THE OHIO STATE UNIVERSITY
Columbus, Ohio

ADDENDUM NO. 1

TO THE DRAWINGS AND SPECIFICATIONS FOR:
PROJECT NO. OSU-110195
Outdoor Sports Complex Renovation

OSU Outdoor Sports Complex Renovation
Heapy Job # 2010-07123

SK-E304a

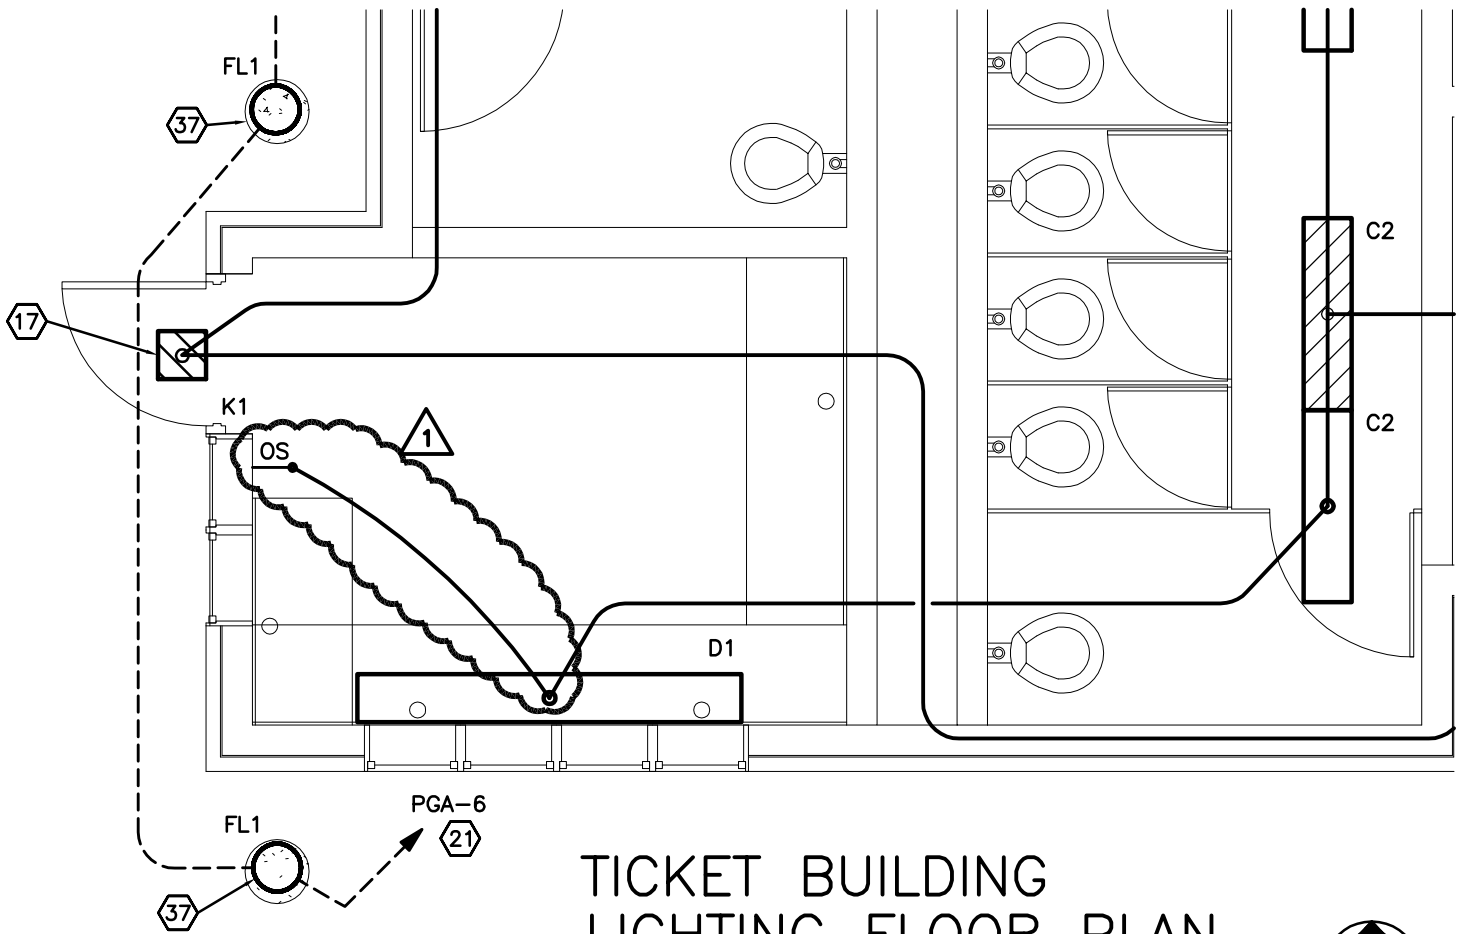
A. Sheet E304 Power & Lighting Floor Plan

- i. Provide conduit and wire to light switch in the ticket office per attached sketch SK-E304a.
- ii. Lighting Fixture Schedule – Fixture “C2”, include Luminaire Lighting as an Other Acceptable Manufacture.

SEDIMENT BASIN AND DEWATERING SCHEME DURING CONSTRUCTION PHASE
NOT TO SCALE

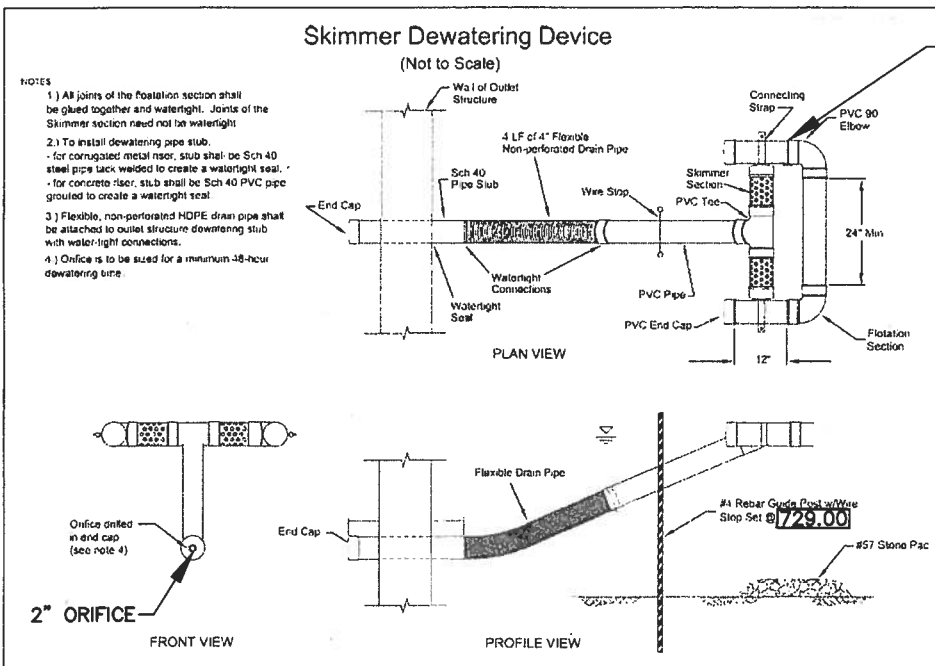
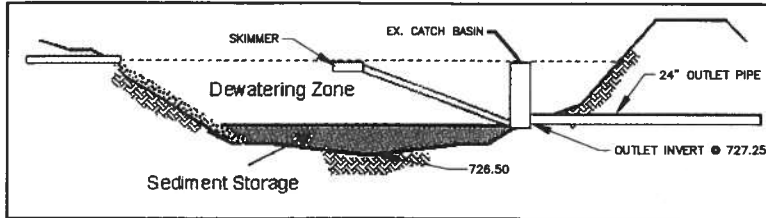
THE DESIGN OF SEDIMENT BASIN AND DEWATERING IS BASED ON OHIO DEPARTMENT OF NATURAL RESOURCES "RAINWATER AND LAND DEVELOPMENT" MANUAL. THE CONTRACTOR SHALL STRICTLY FOLLOW THE CRITERIA MENTIONED IN CHAPTER SIX SECTION ONE OF THE MANUAL WHILE INSTALLING AND MAINTAINING THE BASIN.

THE SIZE OF SEDIMENT BASIN IS LARGER THAN REQUIRED FOR EROSION AND SEDIMENT CONTROL AS IT HAS BEEN SIZED TO BE USED AS DETENTION BASIN FOR POST CONSTRUCTION STORMWATER QUALITY AND QUANTITY CONTROL.

IF CONTRACTOR SELECTS, ALTERNATIVE DEWATERING PLAN COULD BE SUBMITTED FOR APPROVAL.

THE SKIMMER SHALL BE WRAPPED W/ FILTER FABRIC
